600 E Pike

Design Review Board Recommendation Meeting

600 E Pike Street, Seattle, WA 98122

DPD #3014172

Revised Architectural Concept: Connectivity & Tension

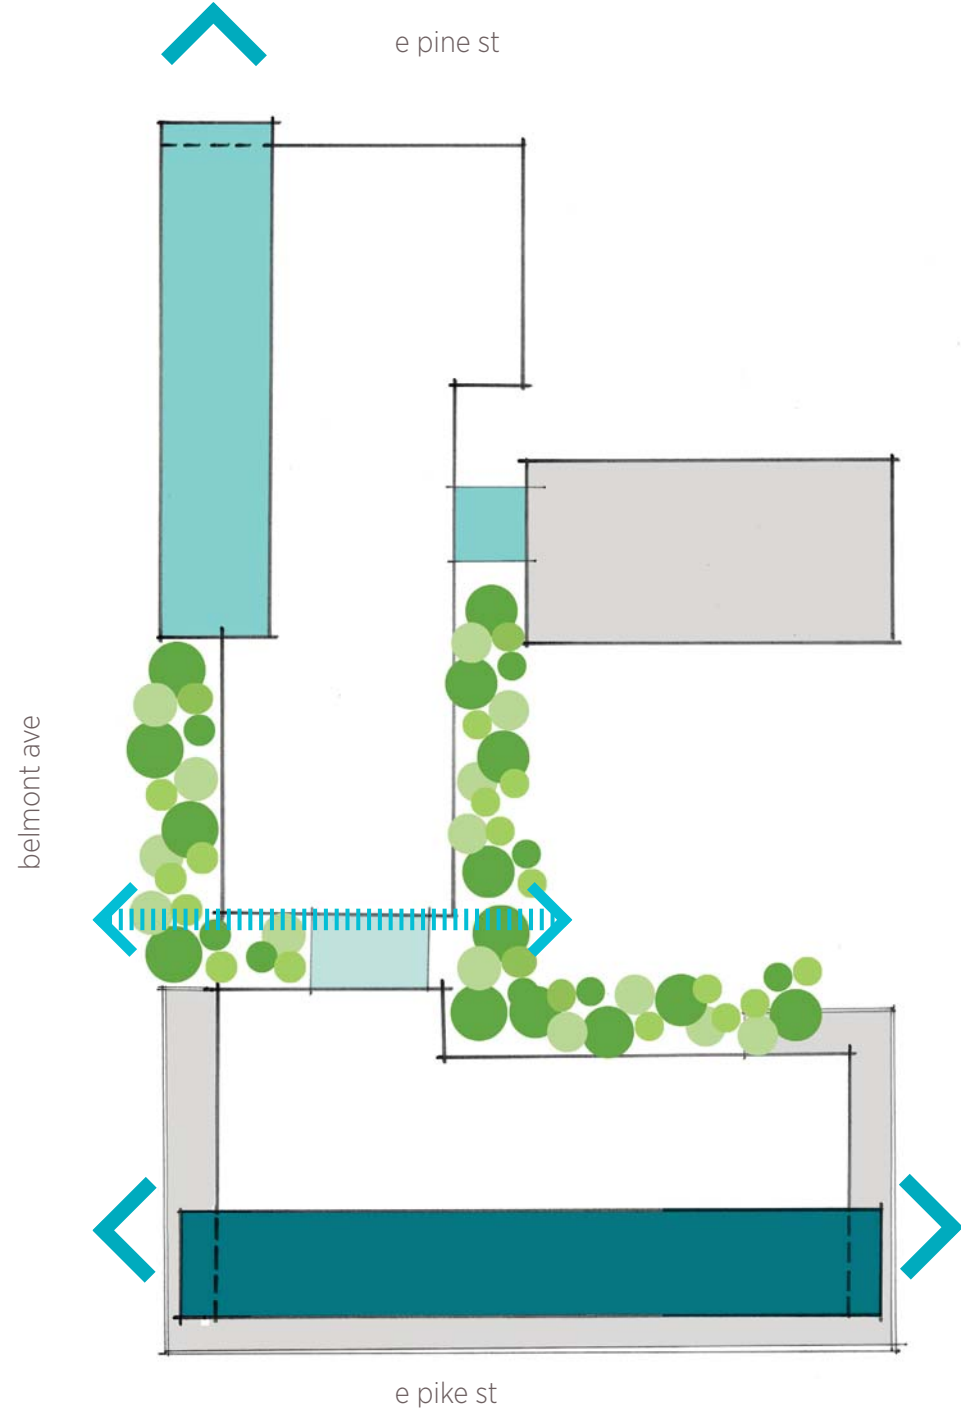
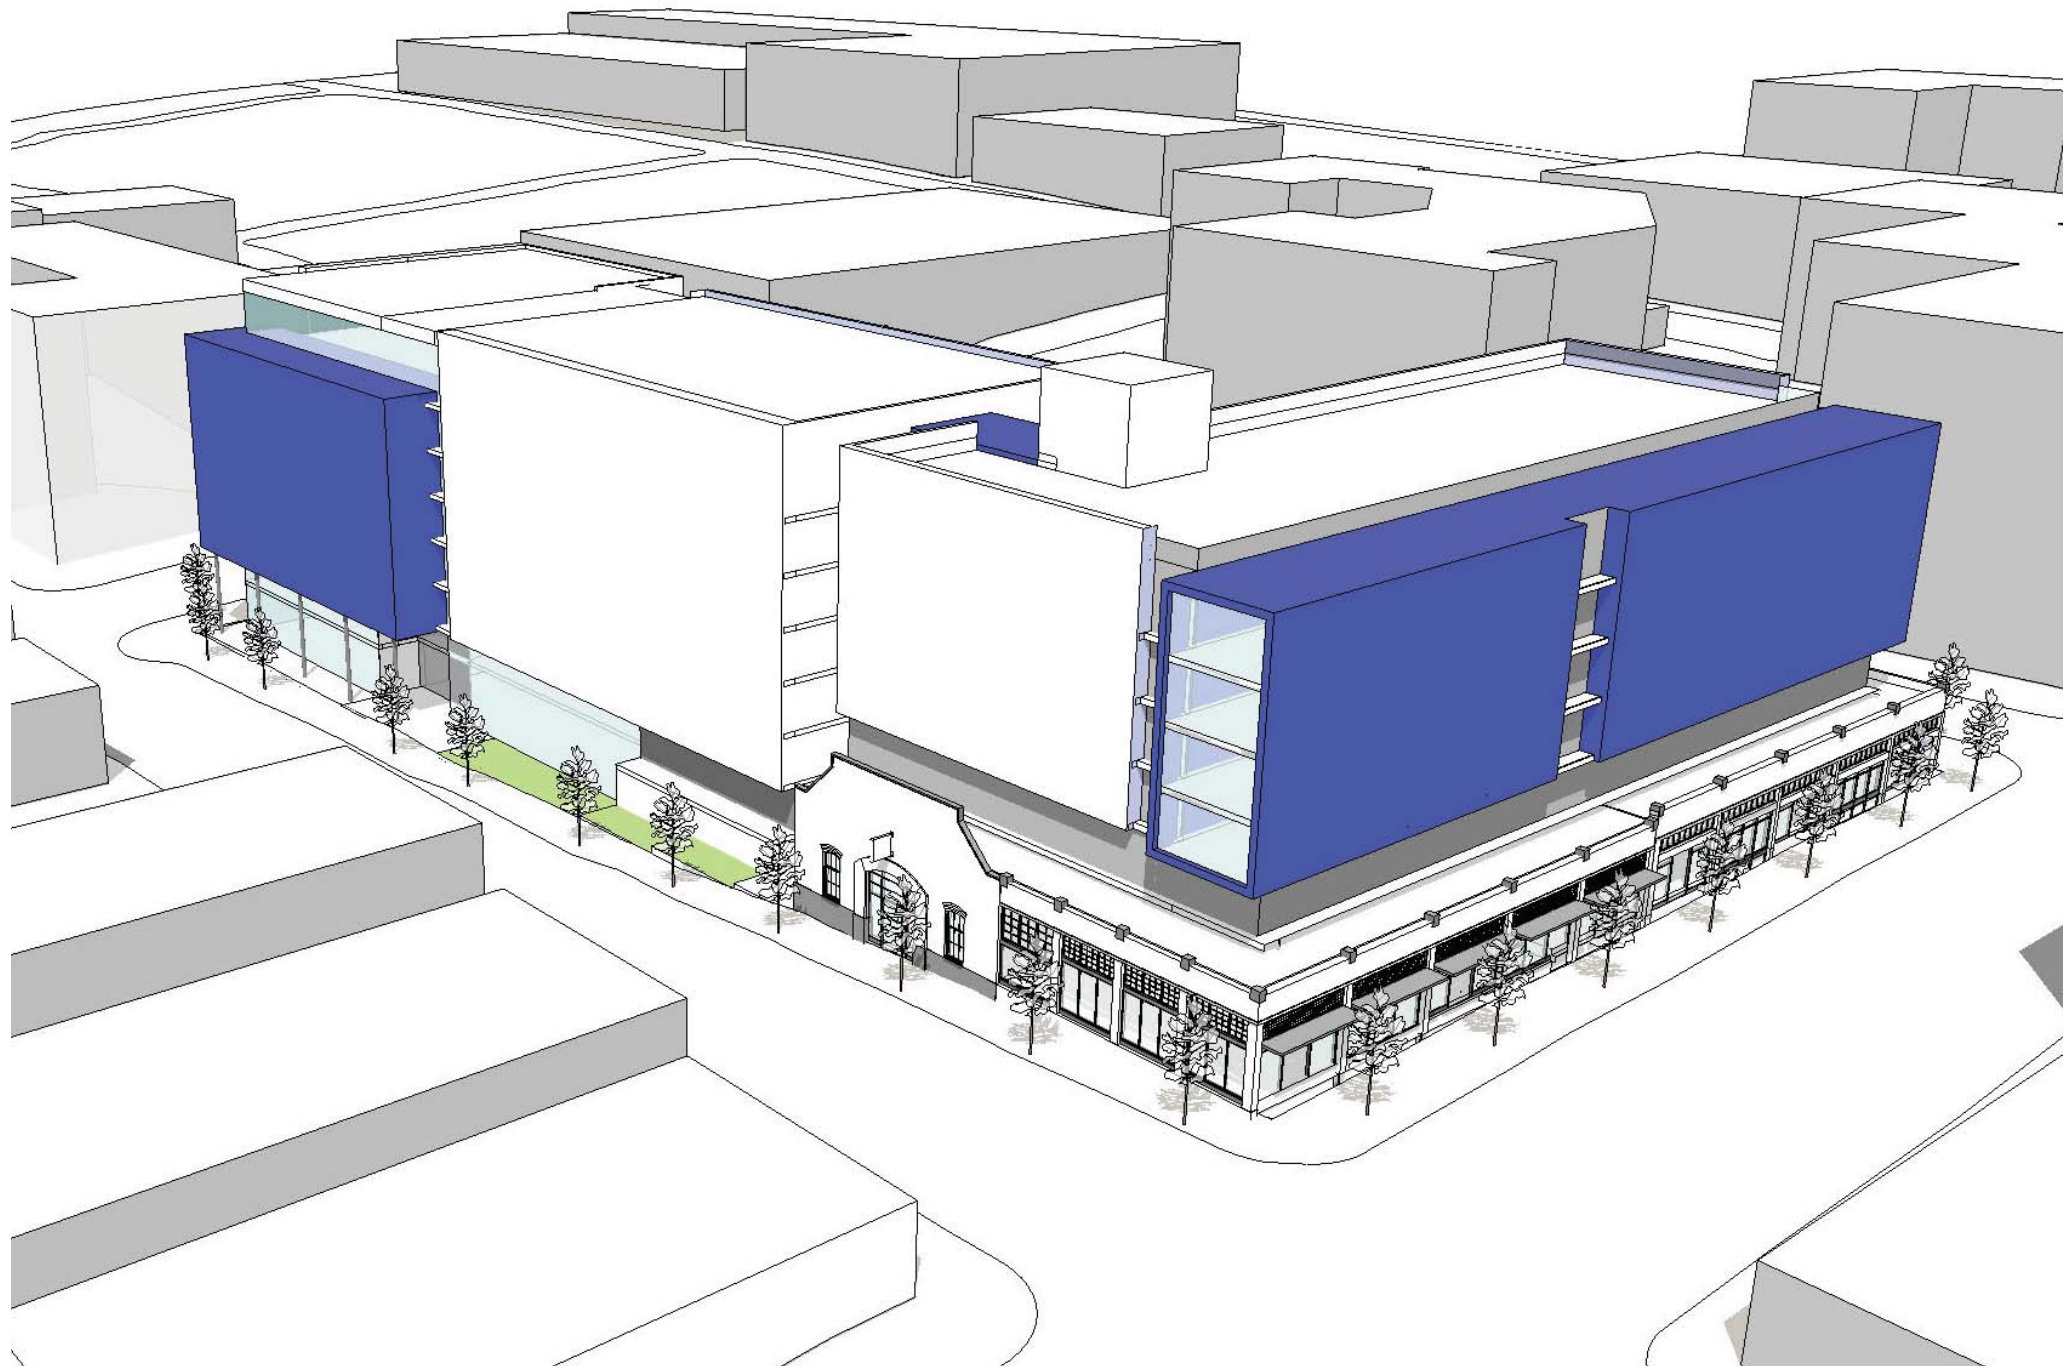
- “Folded plane concept may be challenging to pull off while creating a scale that relates to nearby context.”
- “Inspiration images...provide a better indication of how to achieve smaller scale and visual interest.”
- “Recently reviewed BMW site development held back the top floor as a way to reduce the scale of the building... proposed folded plane concept could provide successful modulation in an alternative to upper level setbacks.”

The design team kept the strong ideas of connectivity and tension and found a more appropriate expression.

- Distinct floating connectors are attached to the north building along Belmont and on the south building above the Pike facades.
- The connectors are clad in a stainless steel panel to recall the auto row heritage and the ends of the connectors are highly transparent.
- The transparent connector is a prominent element at the pedestrian plaza on Belmont and ties the north and south buildings together.
- The metal and glass gasket element separates the new elevation from the historic facades.
- All building masses are treated similarly and are background to the connectors and the retained character structures.

Design Option Retaining the Tree

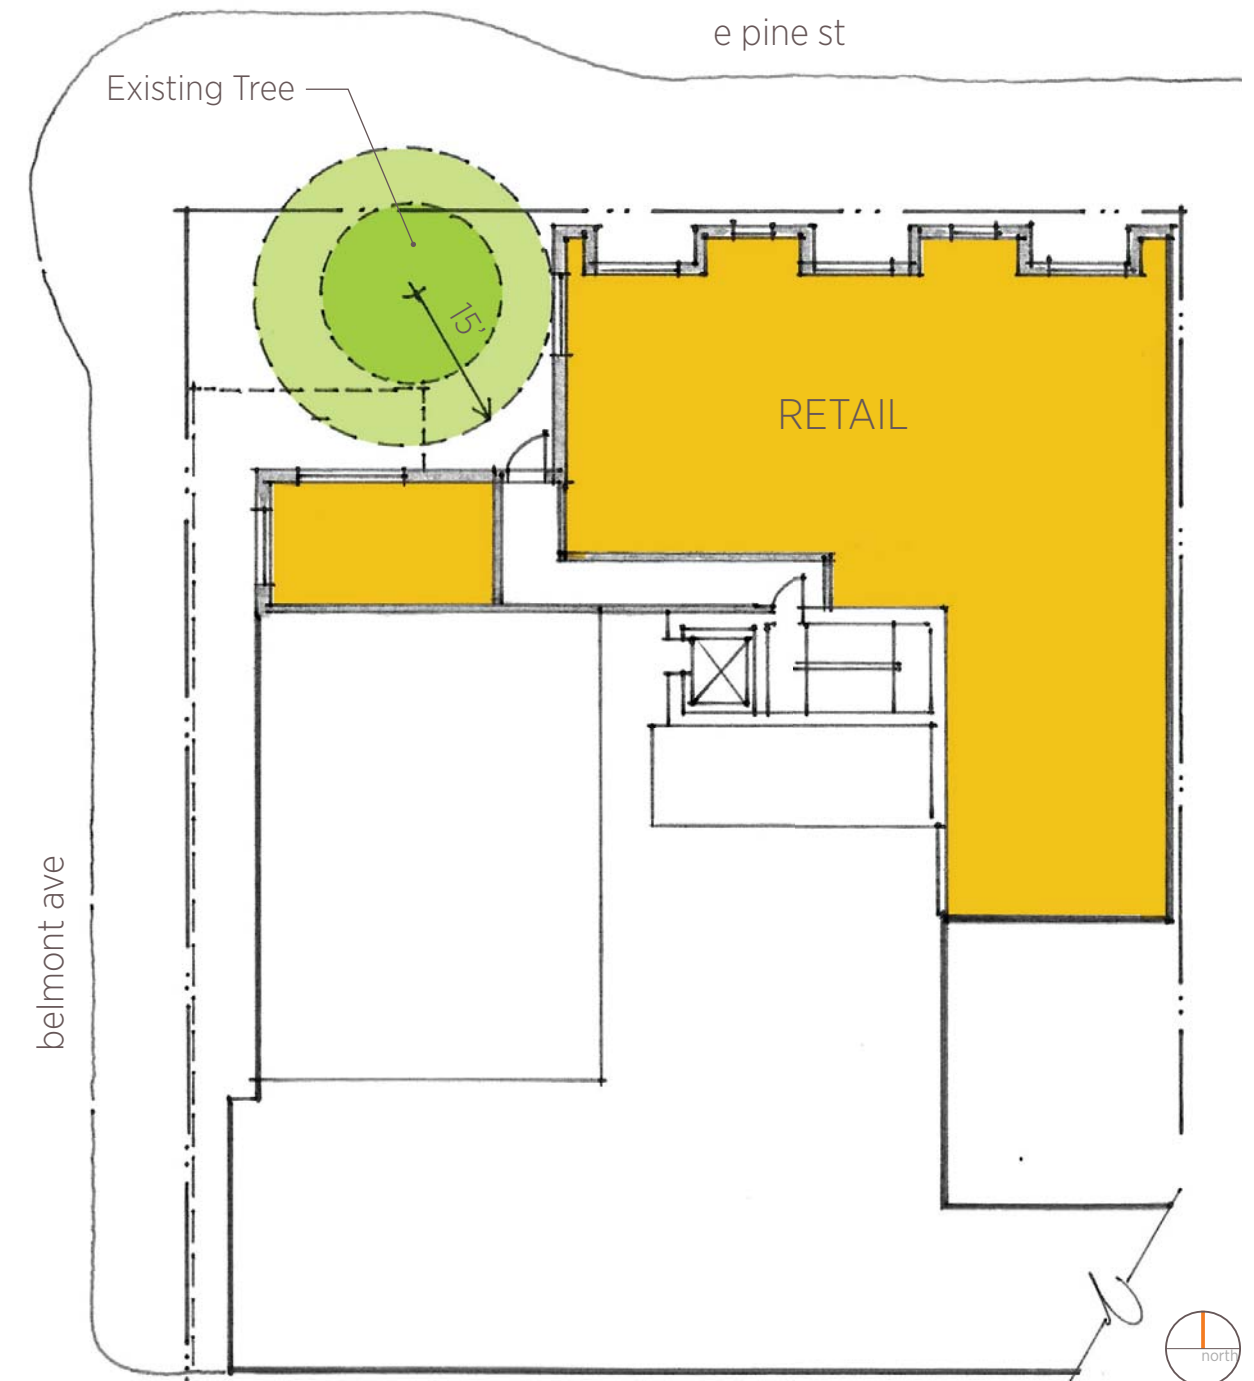
- There is a multi-stemmed maple at the northwest corner of the site, defined as an “exceptional tree” by the City of Seattle due to the combined diameter of its multiple small trunks.
- The design team feels that by removing the tree, this project will better meet the Design Guidelines than an alternative design that requires departures to retain the tree. We request the Design Review Board to recommend the proposal as such.

Both east and west of our site along Pine Street, retail uses open directly to the public sidewalk. Pine Street is a lively commercial corridor with active and transparent retail facing the street. Any design option which retains the tree would push the proposed building away from the sidewalk, hindering its desirability to retail tenants and limiting visibility and access into the proposed retail for pedestrians. We want to strengthen the streetscape along Pine Street with transparent retail built at the back of the sidewalk, which we've accomplished in the proposed design.

In order to retain the existing tree, we would need to depart the following code requirements:

- 23.47A.008. Street-level street-facing facades must be located within 10' of the street lot line unless wider sidewalk plaza or other approved landscaped or open spaces are provided.
- 23.47A.008.B.3. Retail spaces must be a minimum of 15' in depth.

These departures, however, would not be warranted as they do not better adhere to the relevant design guidelines.
